03 March 1999  
File No. 74167-001

Subject: Response to NJDEP 3 February 1999 Letter  
Hexcel Corporation  
Lodi Borough, Bergen County, New Jersey  
ISRA Case No. 86009

FIGURE 1

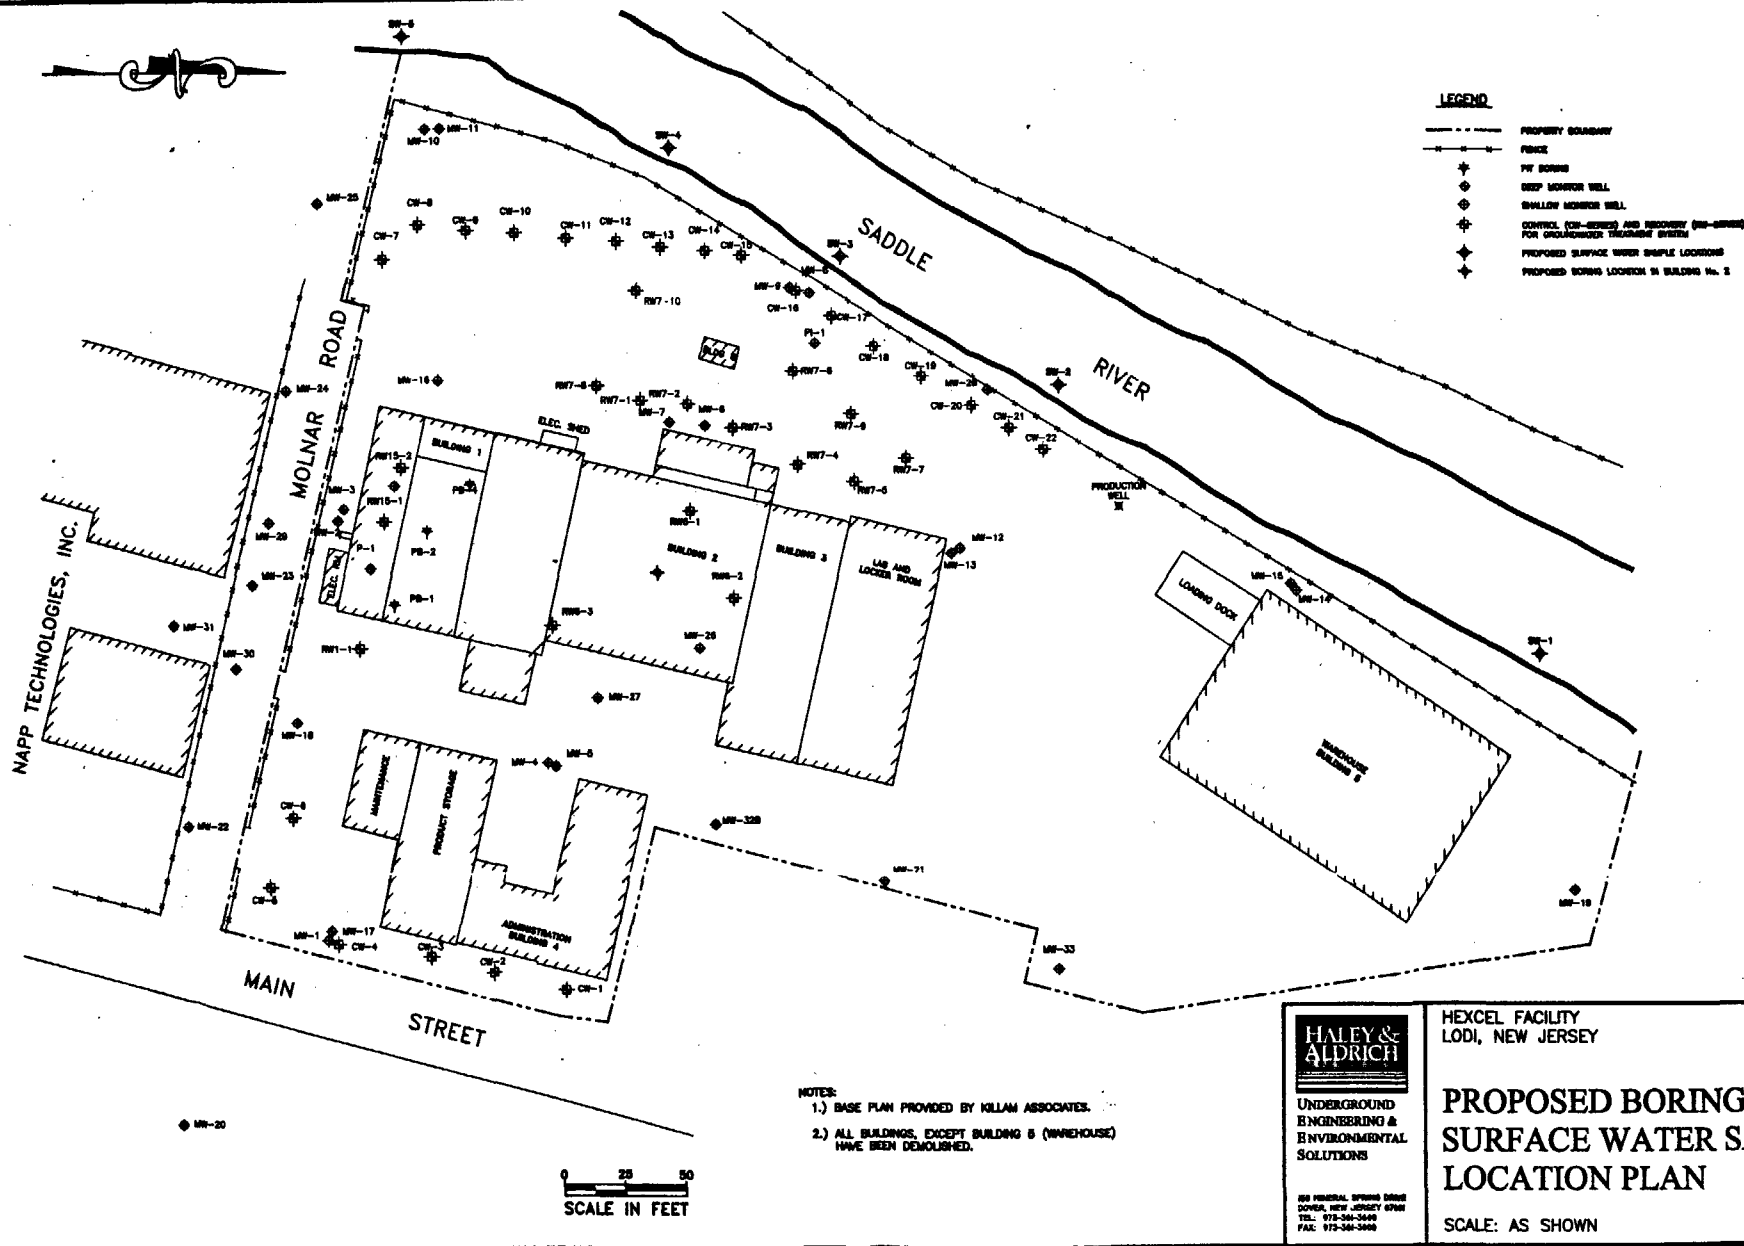
Hexcel proposes to install a boring in the former Building 2 area to define the extent of the confining layer and investigate the presence of DNAPL in this area. The boring location is shown in Figure 1. If the confining layer exists, the boring will be terminated at the top of the confining layer. Continuous sampling will be performed for visual inspection and field screening. The boring will be completed as a shallow monitoring well only if DNAPL is observed in the soil core samples. If the confining layer is absent in this area, this would imply that the construction fill for the subsurface structure extends through the confining layer. Although this scenario is unlikely, the boring location will then be completed as a "deep" monitoring well in this case. The monitoring well will be completed with the top of the screen set at about 3.0 NGVD elevation, which is comparable to the top of the screen elevation for the nearest deep monitoring well MW-7. Hexcel will perform the activities following NJDEP's approval of the proposal.

The NJDEP has required surface water samples at seven locations based on sample spacing of approximately one sample every 60 feet approved for Napp. Based on results of the stream boring investigation, provided to the NJDEP in the January 1999 progress report, the above-referenced spacing is unnecessary for the Hexcel site. Hexcel proposes to collect a total of five surface water samples (3 at approximately 100 foot spacing in the

vicinity of MW-8 and one upgradient and one downgradient) to evaluate the impact to surface water (refer to Figure 1 for proposed sample locations). This sampling frequency is more than adequate to meet the objectives of testing discharge to the River and evaluating the impact to the surface water. The need to include BNA and metals testing for surface water samples will be evaluated based on the results of the groundwater testing proposed in Section II.5 above. Therefore, surface water sampling will be performed upon NJDEP's approval of the proposed sample locations and additional groundwater testing proposal, and evaluation of the groundwater testing results.
